PONTIAC HISTORIC DISTRICT COMMISSION

March 13, 2024, 6:00 pm CITY HALL – 2nd FLOOR – COUNCIL CHAMBERS 47450 WOODWARD AVENUE – PONTIAC, MICHIGAN

Application: HDC 24-002 369 W. Iroquois Road

HDC 24-002 369 West Iroquois Road

Figure 6 – sample of Vinyl Siding

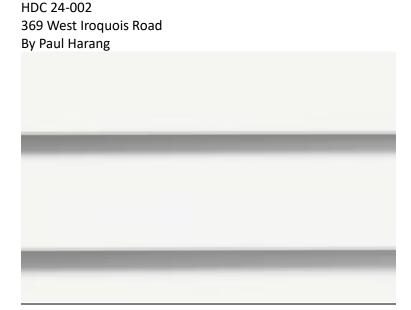
Per the Pontiac Historic District Commission Guidelines for siding, "installation of new vinyl or aluminum siding over original historic fabric (clapboard, cedar shingles, or other material) is strictly **prohibited** ". "if

The applicant indicated the wood siding on the garage was "very deteriorated" therefore, he covered the garage walls with vinyl siding to mimic the siding on the dwelling. However, this alteration is not consistent with either standard/ criteria.

Staff recommends **DENIAL** of the request to install vinyl replacement windows on the primary façade, vinyl siding on the garage walls, and covering windows with siding in the garage.
